Bentley Bulletin

23-023

Subject: NON COMPLIANCE RECALL - SEAT AIR BAG MAY TEAR (RE23/03)

NON COMPLIANCE RECALL - SEAT AIR BAG MAY TEAR/FMVSS 214 & 208 (RE23/03)

Figure 2

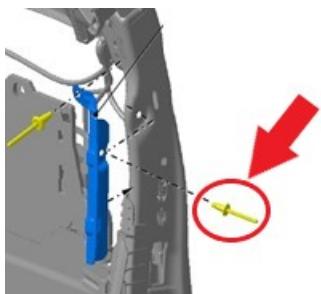
Only the side rivets shown in Figure 2 are affected on the left and right hand side front seats

Checks are required to be conducted on the left and right hand front seat side rivet mandrels (all vehicles)

Figure 2

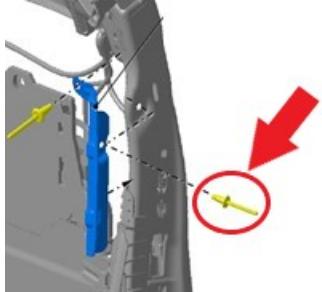
Only the side rivets shown in Figure 2 are affected on the left and right hand side front seats

Checks are required to be conducted on the left and right hand front seat side rivet mandrels (all vehicles)

Figure 21

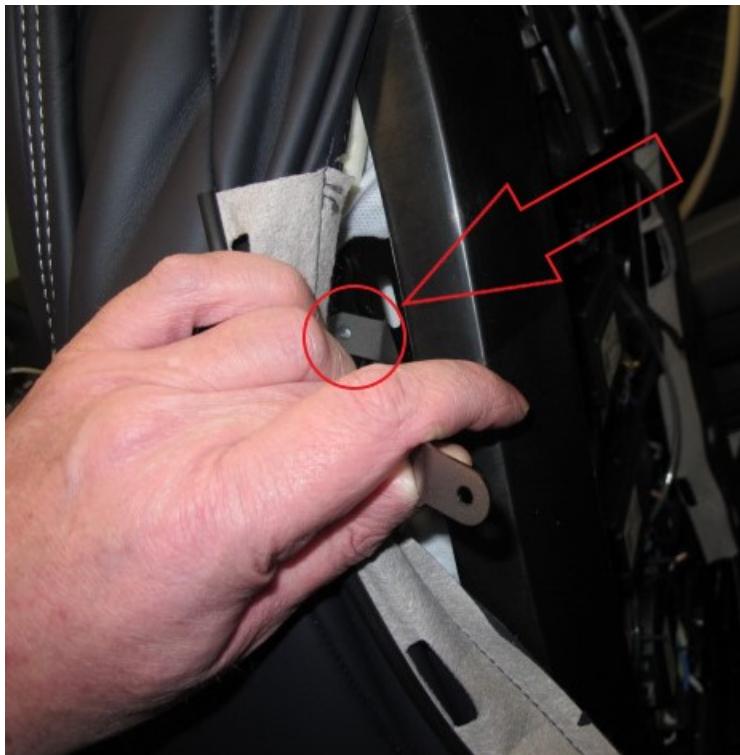
7) Referring to Figure 21 - Using WT10662 the operative should measure the protrusion of the rivet mandrel as follows:

- Position WT10662 over the rivet head/mandrel as shown

Figure 22

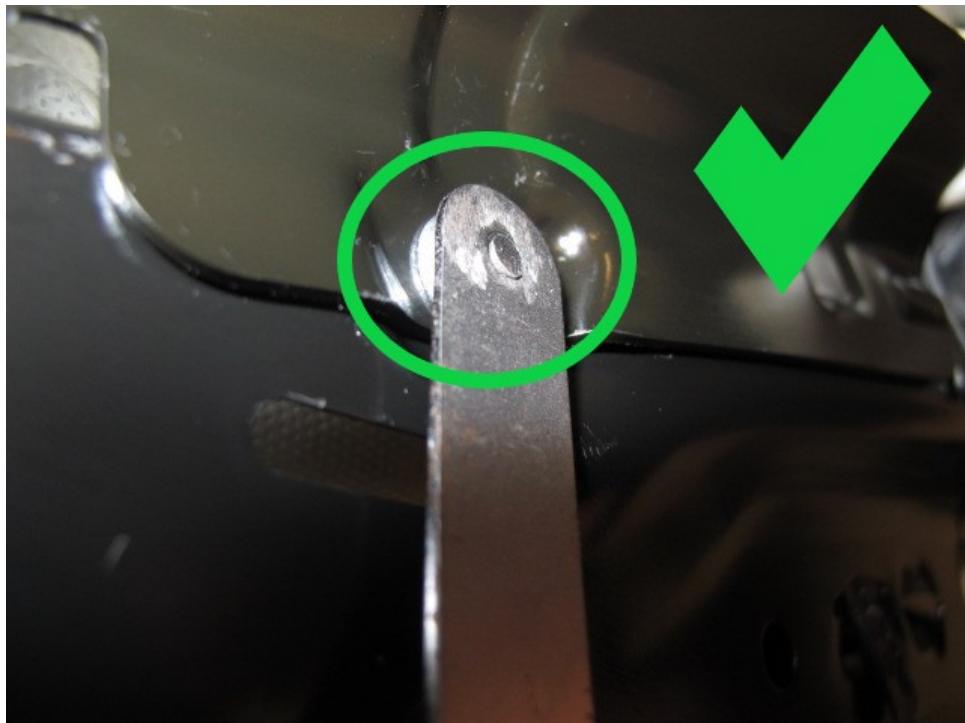
- In the event the mandrel is protruding <1mm (Less than or equal to 1mm) as shown in Figure 22 - Proceed to step 8

- The mandrel is not protruding Figure 23 - Proceed to step 8

Figure 24

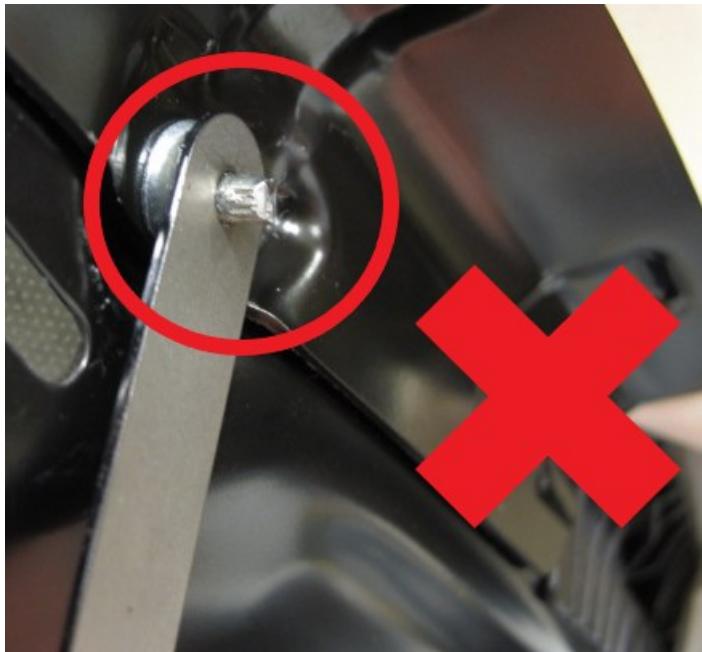
In the event the mandrel is protruding as shown in Figure 24 >1mm (greater than 1mm) the operative must conduct the mandrel rework procedure within Section 2 to completion

Figure 27

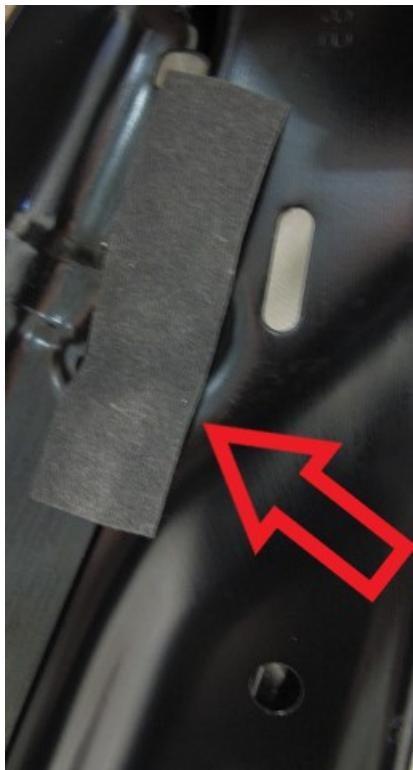
- 9) Referring to Figure 27 - Apply the first Paraskin strip at the location shown

Figure 28

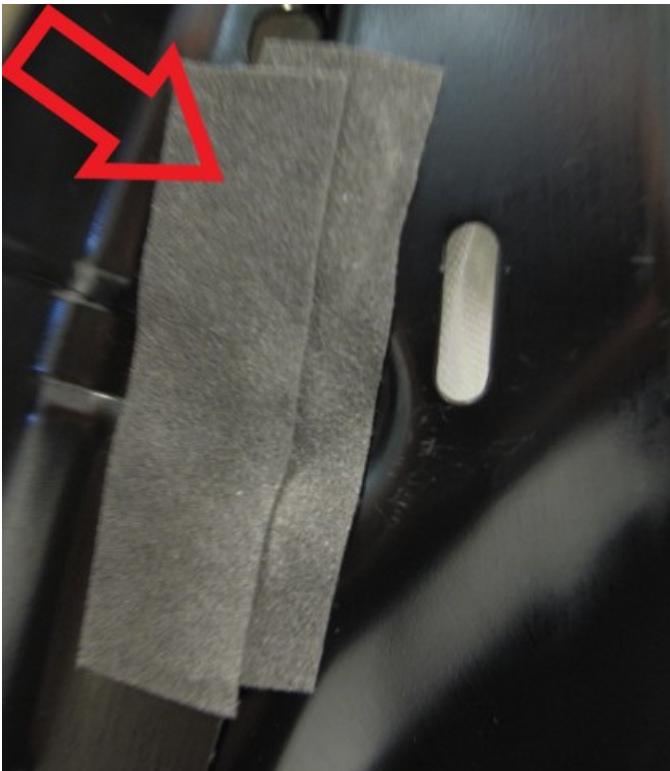
- Referring to Figure 28 - Apply the second Paraskin strip at the location shown
